Feasibility Study

**Wendover Avenue (SR1541)
From Sapp Road To NC. 68
Guilford County**

**Prepared By
Thoroughfare Planning Unit
Planning and Research Branch
Division of Highways
N.C. Department of Transportation**

ADDENDA

SIX LANES DIVIDED WITH GRASS MEDIAN - URBAN

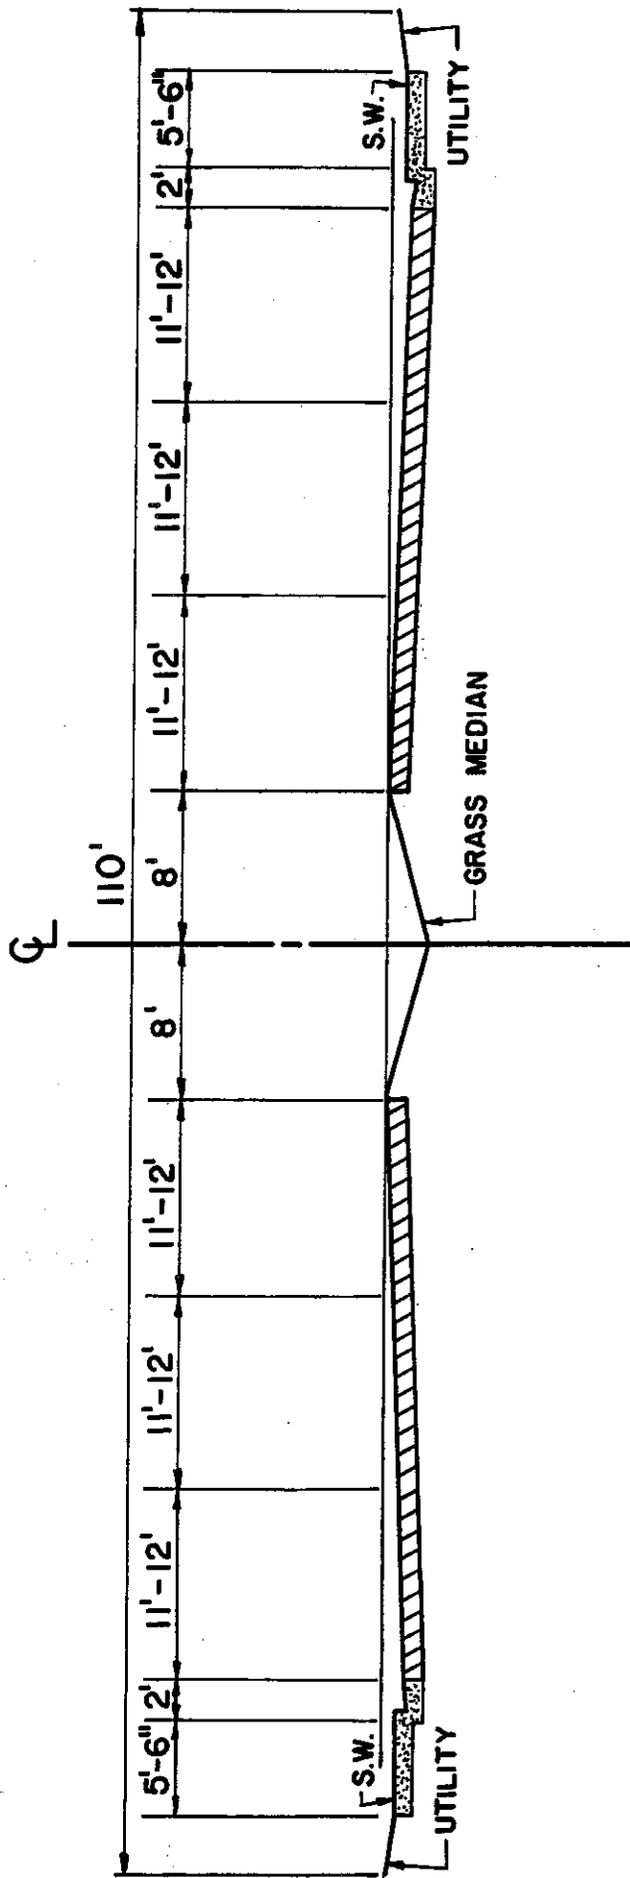
The thoroughfare cross section, as reported in this preliminary studies report shows a 16-foot median. 16' median will be adequate only for berm type (raised median) construction. Swale (Ditch) type median needs 26' minimum + 2' paved inside shoulders (30' total). This extra width also provides for double left lanes when and where needed. Therefore, if a grass median construction is desired, a minimum of 124' right-of-way should be anticipated.
